**WSR16-0094**

# Request for Well and Septic Service

Date of Request: July 22, 2016  
Site Address: 9425 Ben Way  
Service Requested: **Site Review**

## Pre-Perc Field Notes

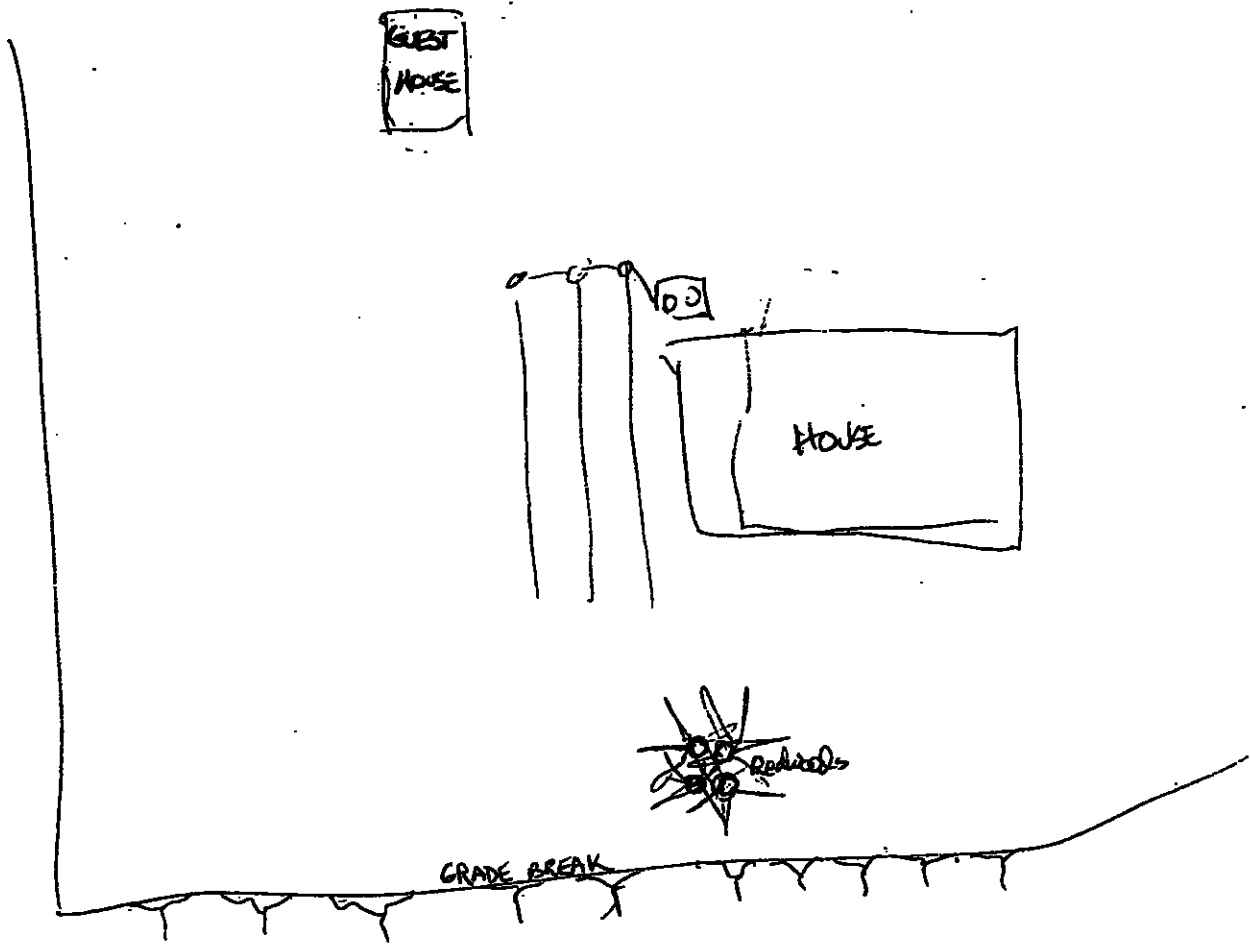
Hydrometer test: Yes <input type="checkbox"/> No <input type="checkbox"/> Depth(s):		Bulk density: Yes <input type="checkbox"/> No <input type="checkbox"/> Depth:
Wet-weather perc required: Yes <input type="checkbox"/> No <input type="checkbox"/>		Wet-weather groundwater required: Yes <input type="checkbox"/> No <input type="checkbox"/>
Subsoil perc depth(s):		Pump System: Yes <input type="checkbox"/> No <input type="checkbox"/> Perc depth(s):
Type of system: <u>Existing 2 BR house w/ 1 BR Garage</u> Eng. Design <input type="checkbox"/> Topographic map req. <input type="checkbox"/> Geology report req. <input type="checkbox"/>		
Comments: <u>wants to connect second unit on composting toilet into existing system. potential infiltrators over existing gravel trenches - 1st line plugged w/ roots (remove Orangeburg &amp; 9" gravel), 2nd &amp; 3rd line can place infiltrators</u>

Site Map: over existing unused lead lines. Original system from 1973 = ~~42~~<sup>48</sup>" deep Hydro between lines #1 & 2 near profile 16-B = Sandy loam. 30" gravel credit. Fee = Addition Repair; Base sizing on old perc tests.
